BID ADDENDUM # 2
TROUT VALLEY NATURE PARK

DATE ISSUED – September 22, 2026

SUMMARY OF CHANGES

SHEET NO.
G002

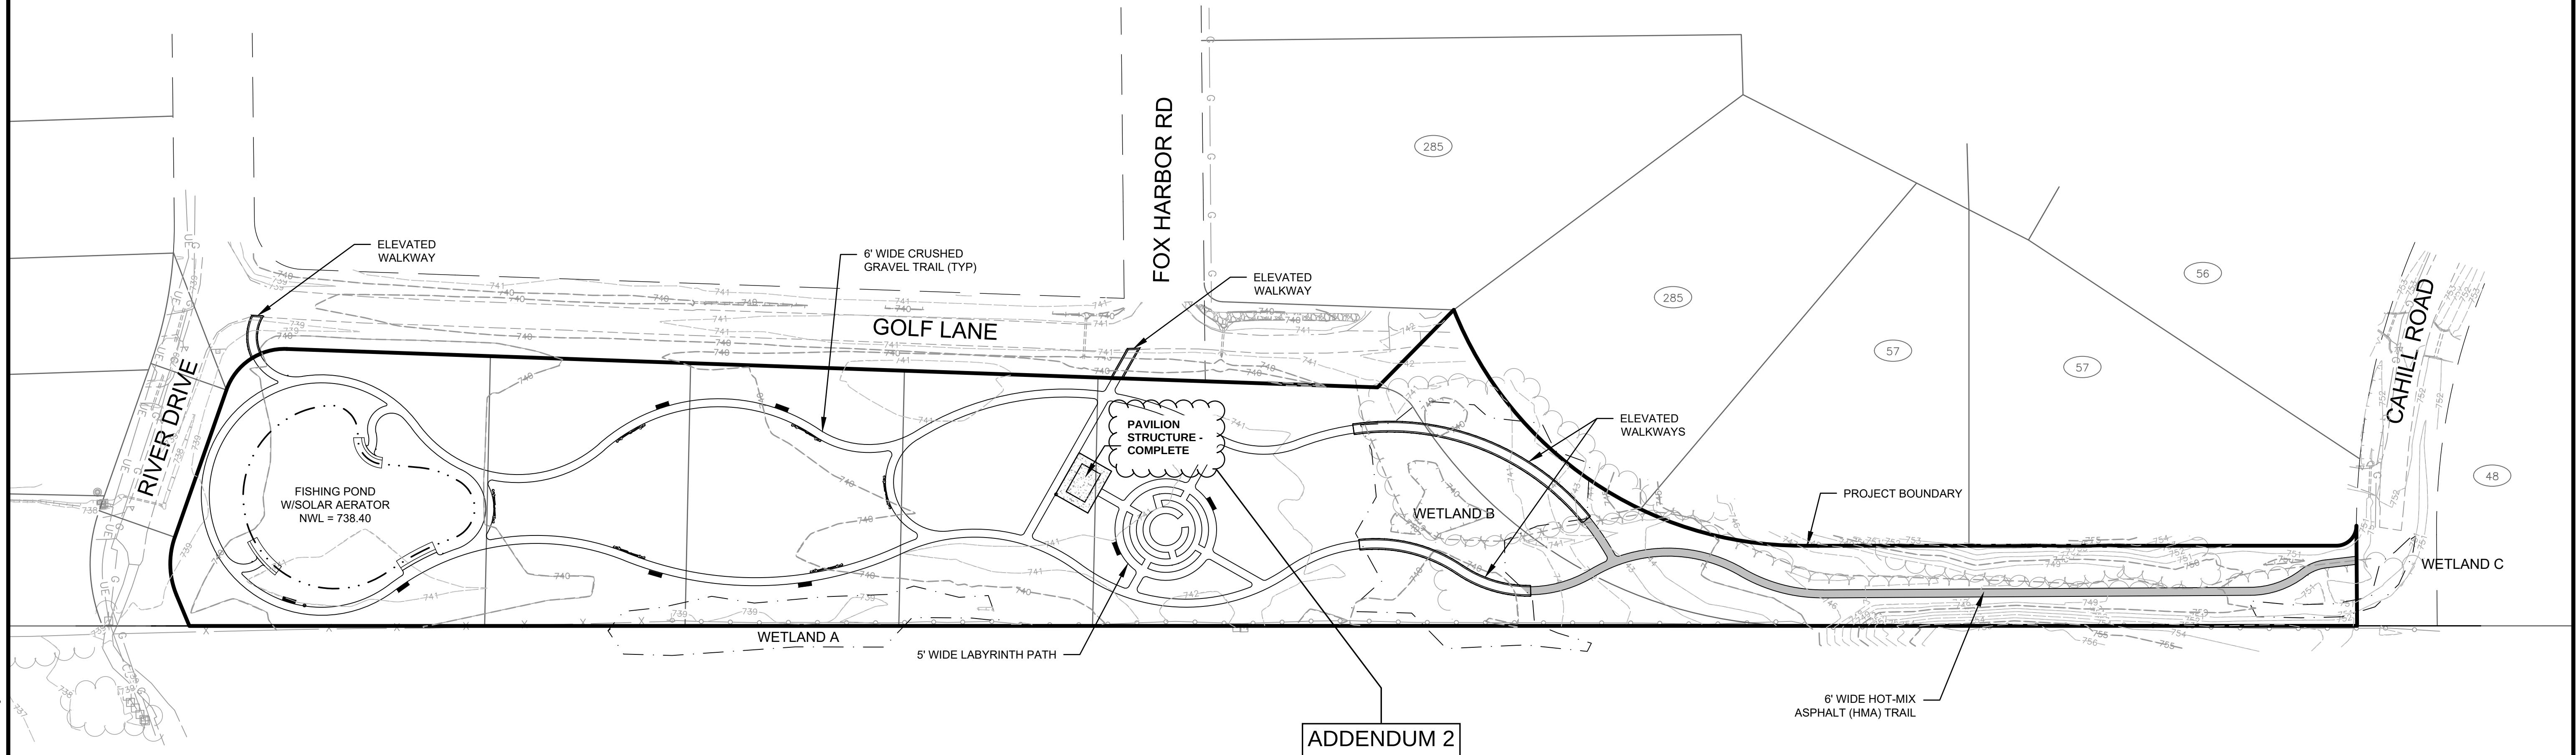
Sheet G001 is amended to reflect the revisions. G002 is amended to reflect corrections in the Summary of Quantities. Sheet G004, C111, are amended to reflect a corrected pay item callout for Pavilion Structure-Complete. Sheet C107-C109 are amended to correct the legend to show tree stump removal. Sheet L102-L104 are amended to correct the legend to clarify the Pavilion Structure Complete Detail location. Sheet L504

3 BENCH

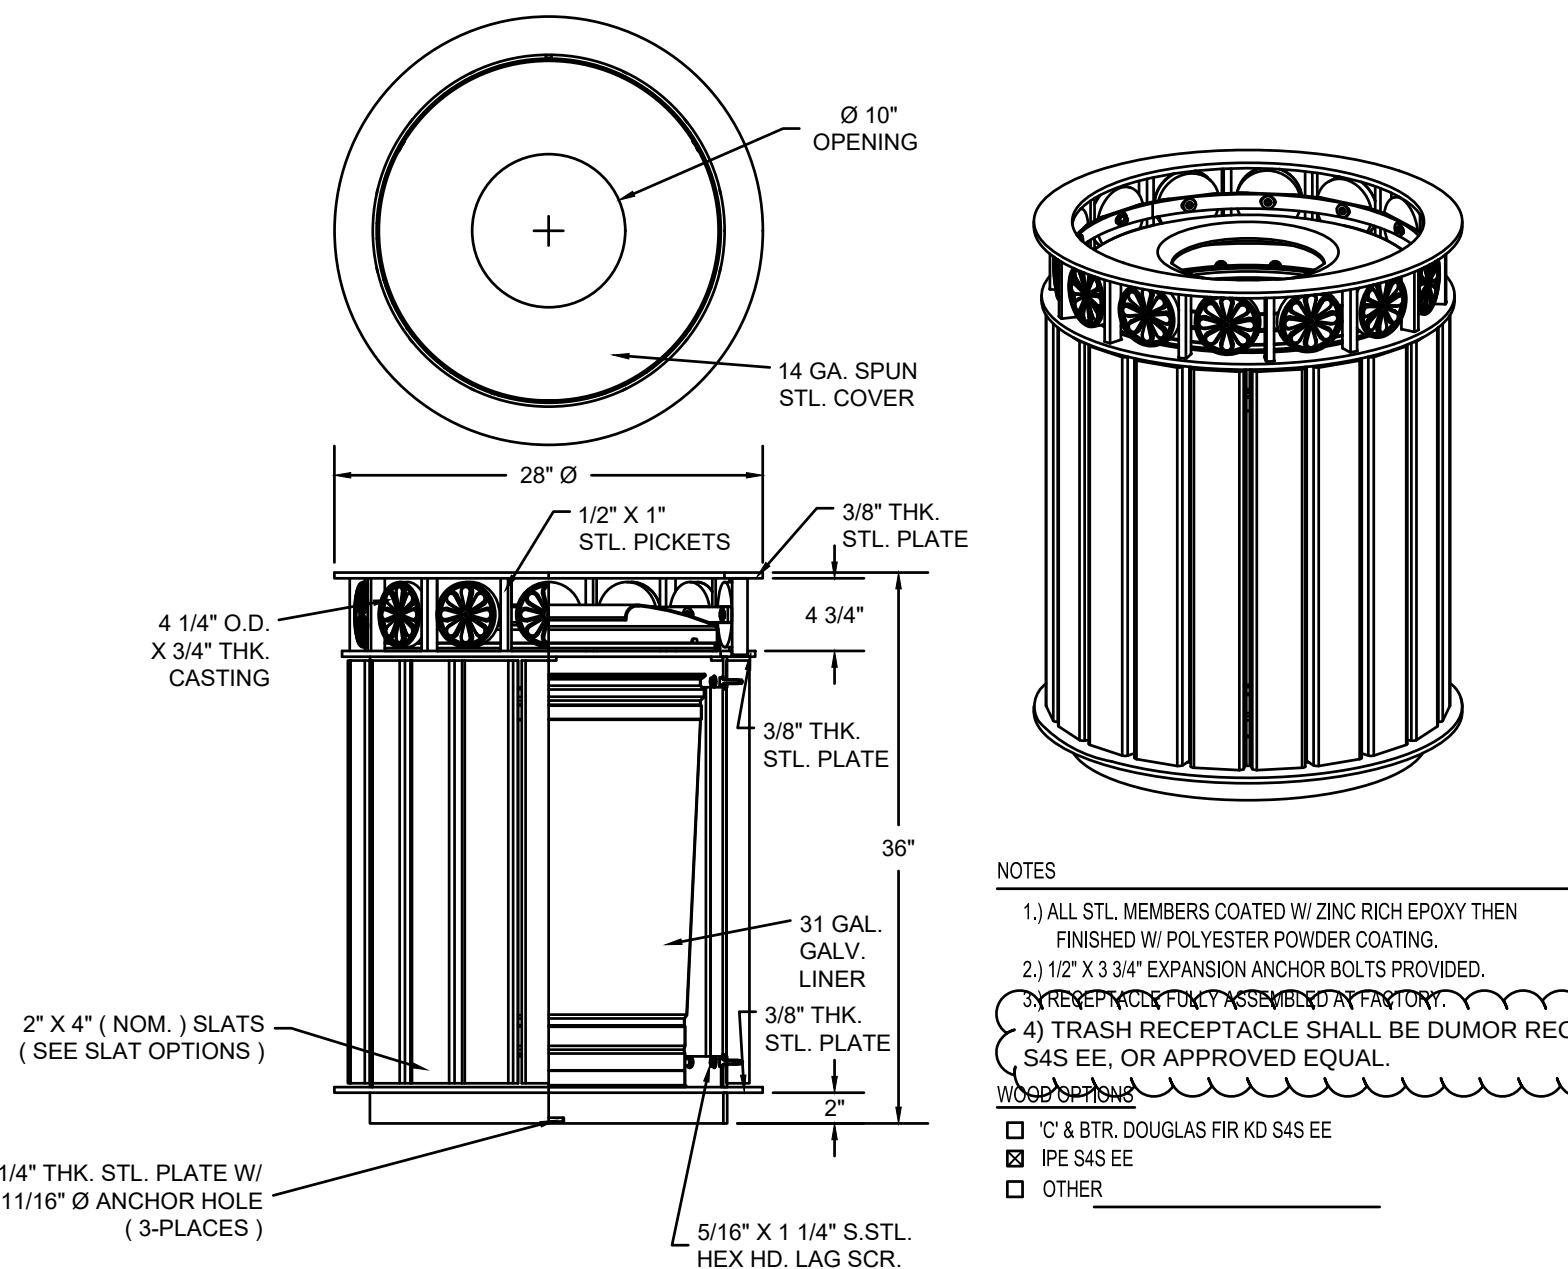
is amended to include submittal requirements on manufacturer information for Bench, Trash Receptacle, Dog Waste Station, and Fishing Line Recycling Bin.

CONTRACTOR TO SUBMIT MANUFACTURER INFORMATION FOR OWNER APPROVAL, PRIOR TO INSTALLATION
